2003 Vulcan® 1500 Classic® (VN1500-E6)
 2003/2004 Vulcan® Nomad® FI (VN1500-L4/L5)
 2003 Vulcan® 1500 Mean Streak® (VN1500-P2)
 2003 Vulcan® 1500 Drifter® (VN1500-R3)
 2003 Vulcan® 1600 Classic® (VN1600-A1)
OIL FILTER LEAKAGE

MC 04-04

First Issued: January 23, 2004
 Revised: May 21, 2004

RECALL

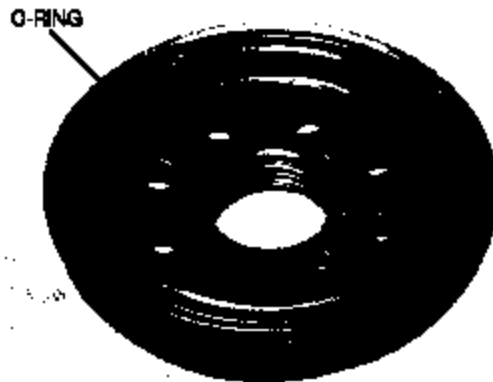
The parts in the kit have been "loosely" assembled.

- o Do not remove the O-ring from the adapter, the two O-rings used in the repair are slightly different sizes.

- Loosen, and remove the adapter from the countermeasure oil filter kit.

- o Keep the element and relief valve together in the new oil filter case.

- o Loosen the O-ring on the adapter.

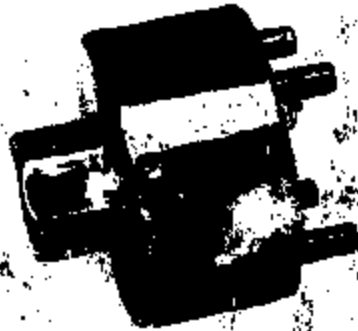
- Apply grease on the loose O-ring in the kit to keep it from falling off during assembly, and fit the O-ring in the groove of the adapter that faces the engine case.

- Install the adapter onto the crankcase with the adapter installation tool (P/N 57001-1598).

Be careful not to damage the O-ring during installation of the adapter.

Oil filter adapter: 88 N-m (10 kgf-m, 72 ft.lb)
